Vesting Tentative Tract Map No.060922-1
Conditional Use Permit No. RCUP201500126
Environmental Assessment No. RENV201500227

SUBDIVISION COMMITTEE REPORT

REVISED TENTATIVE MAP DATED 09/27/2016
REVISED EXHIBIT MAP 09/27/2016

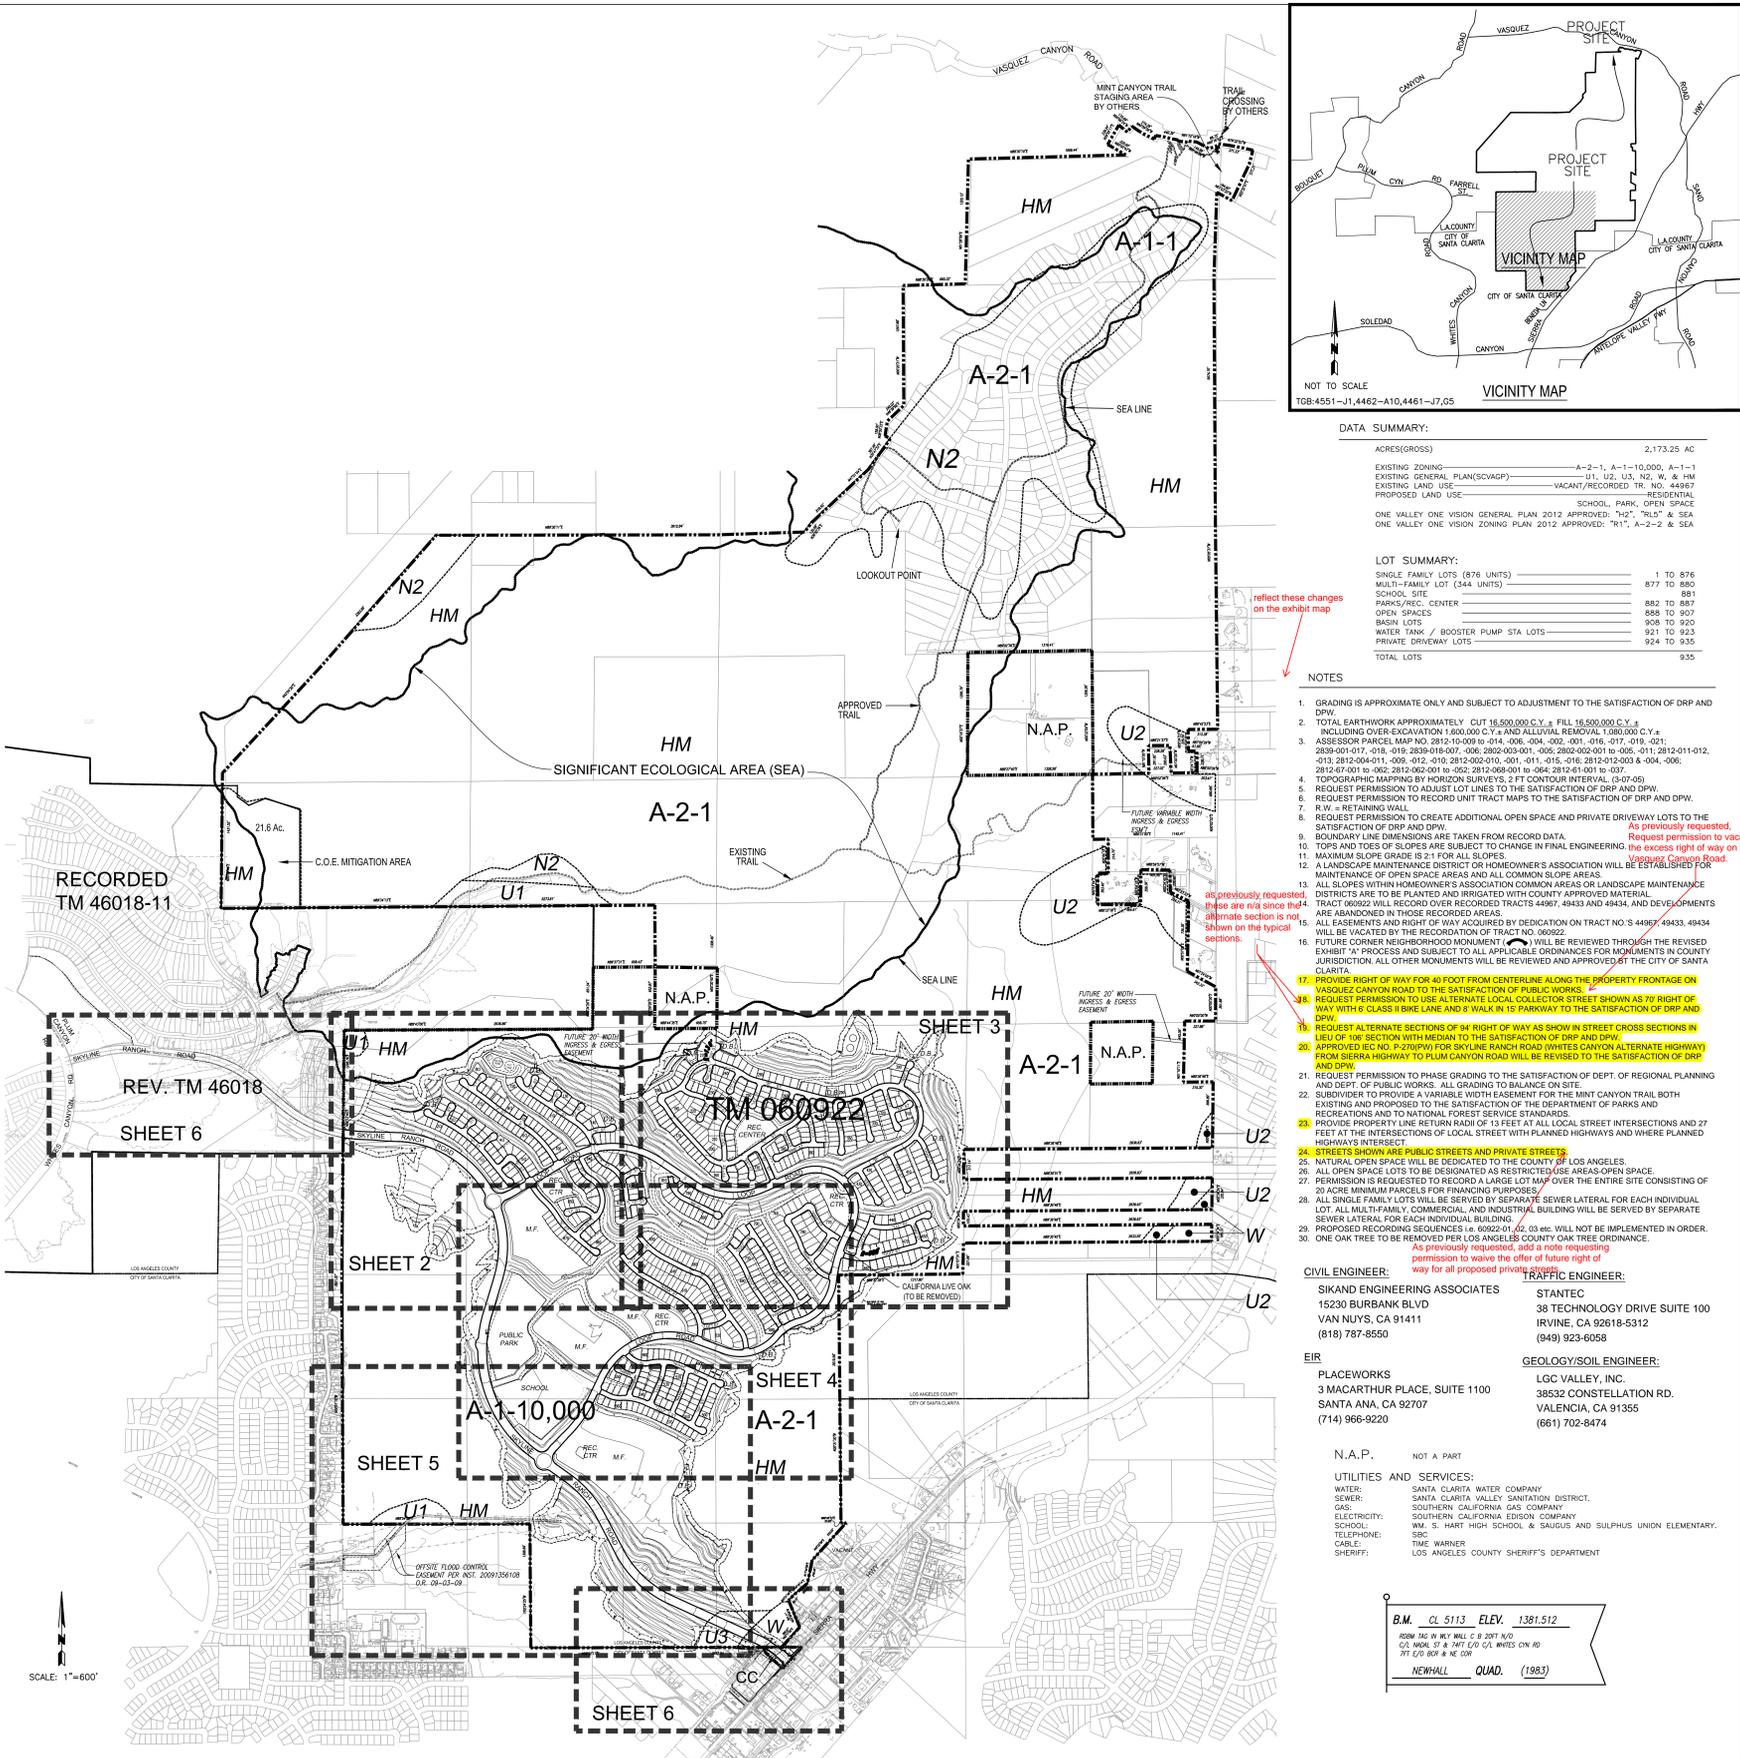
3. As previously requested, the existing zoning and Plan are incorrect. The "2012 approved" is now existing and current. The former was in place at the time of the original tentative map approval. Consistently indicate existing and former.

4. Ensure all existing improvements and stands of vegetation are shown, specifically oak tree(s), and provide the proposed status. The oak tree is noted, yet not depicted.

7. Lot 575 does not meet the minimum required area. Please address by meeting the minimum required area of 5,000 square feet.
8. As previously requested, add linear street frontage of the lots to the lot table.

2. Clearly label the proposed offsite storm drain in and south east of Sierra Highway on the Tentative Map.
3. Clearly show the storm drain within Skyline Ranch Road as shown on the Proposed Conditions Hydrology Map south of lots 877 and 921.

- G2. Show the proposed grading required for the removal of landslides Qls L17 and Qls L27 on the geotechnical maps and Tentative Map. Note: Mitigation of landslide Qls L17 will require offsite grading.

5. A revised tentative map and exhibit map is required. See additional road comments as shown in the attached files (2016-10-20 tr_060922-1_tract-map-20160927 road checkprint.pdf) which can be found at the following ftp link: <ftp://dpwftp.co.la.ca.us/pub/LDD/Road/TTR%2060922/>
